284 BRET ROAD RESIDENCE
CAMERON, HARNETT COUNTY, NORTH CAROLINA

SHEET TITLE:
ELEVATIONS / BUILDING DATA

PLAN NO:
KOENII24

DATE:
NOVEMBER 2024

(C) TYPICAL WALL SECTION
3/4" = 1'-0"

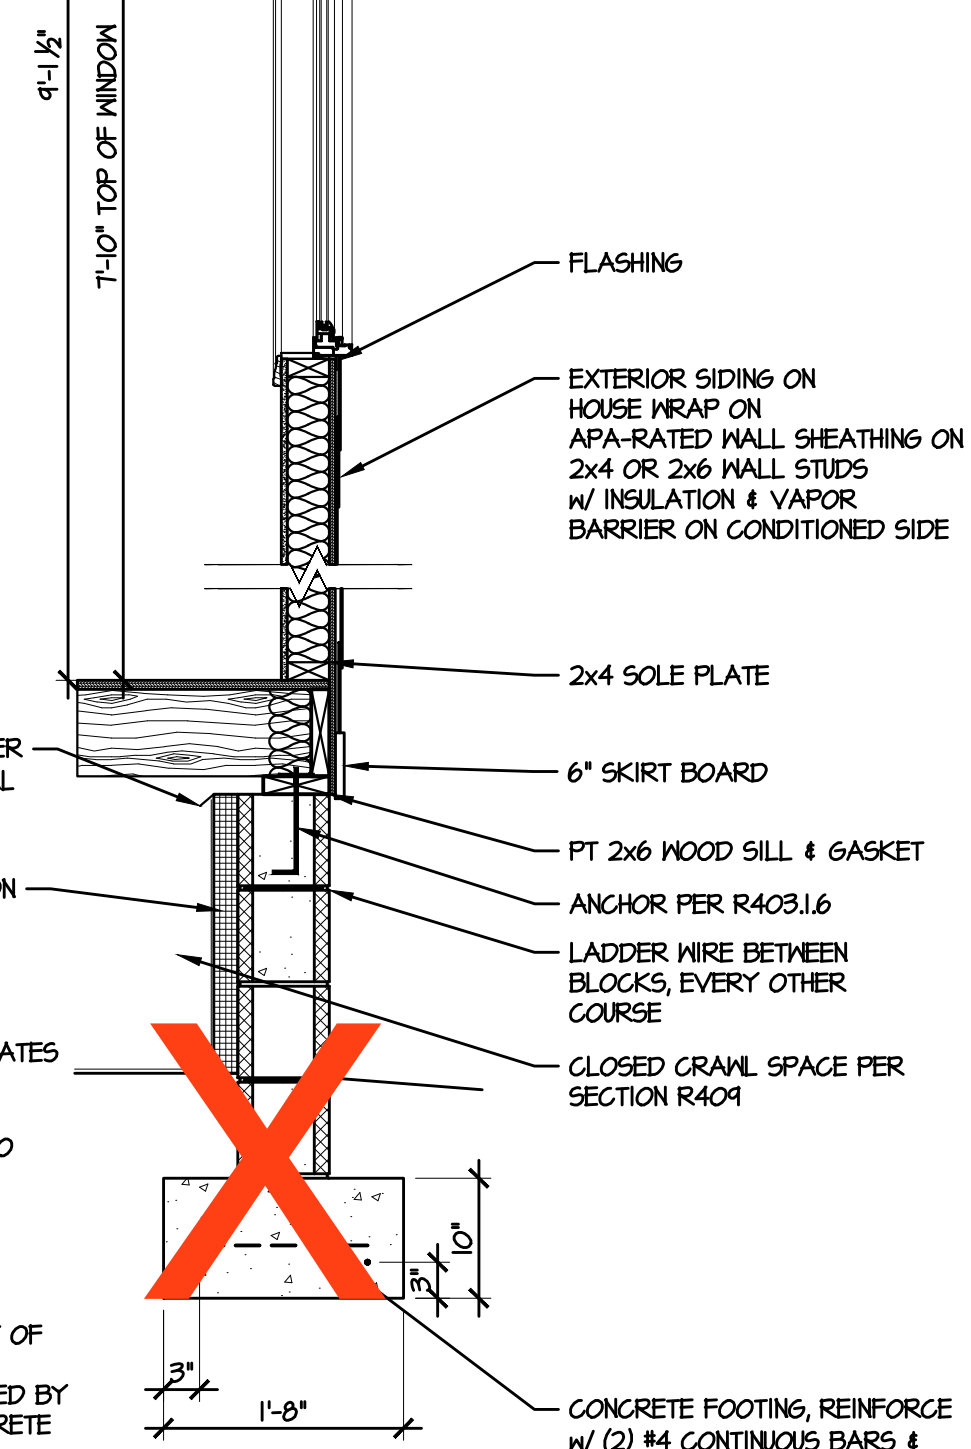
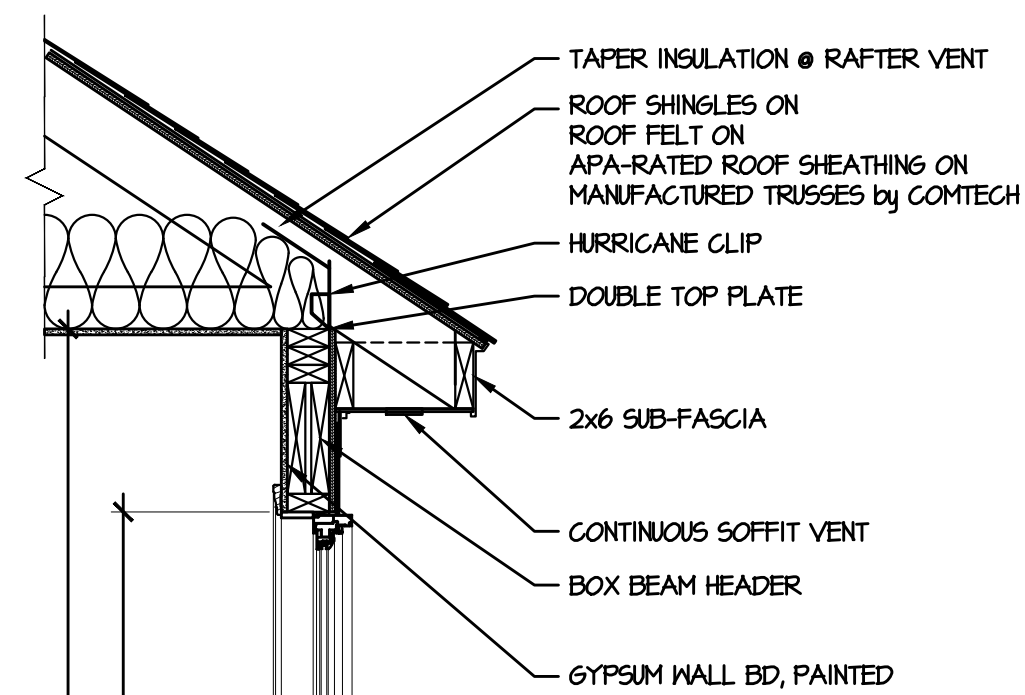
4 and 8 brick and block foundation wall. See attachment.
